DRAFT
ENVIRONMENTAL ASSESSMENT
RUNWAY 6 EXTENSION PROJECT & 5 YEAR CIP IMPROVEMENTS
PLYMOUTH MUNICIPAL AIRPORT
PLYMOUTH, MA

MEPA DEIR SUPPLEMENTAL INFORMATION

MEPA PROJECT #16692 – DEIR SUPPLEMENTAL INFORMATION

C1.1

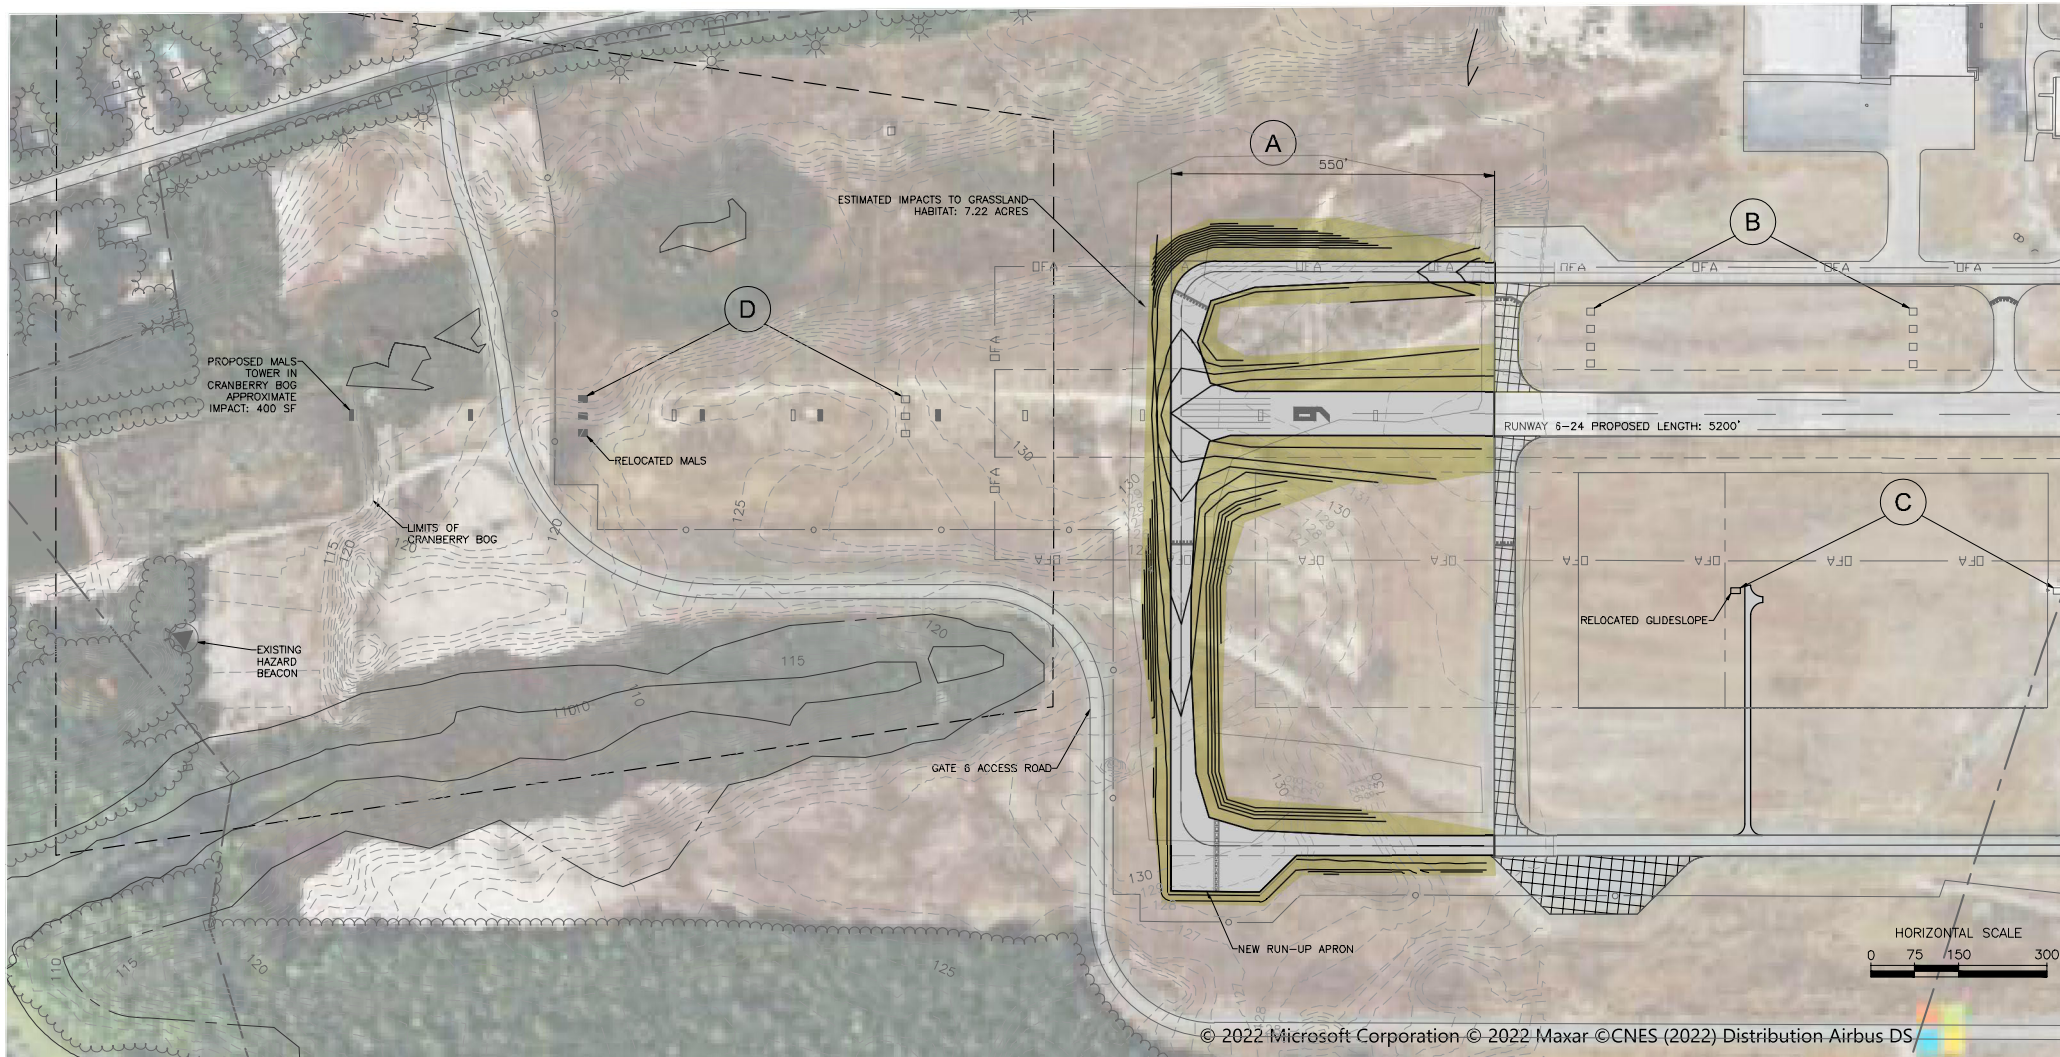
Plans provided with the DEIR do not detail a number of the requested components (e.g., subsurface utilities, surface elevations, stormwater and utility infrastructure).

Attachment 3 – Four D&K early Conceptual Plans (Figures C1.1, C1.2, C1.3, C1.4) showing Alternatives 1-4 included in the MEPA Supplemental Information Response.
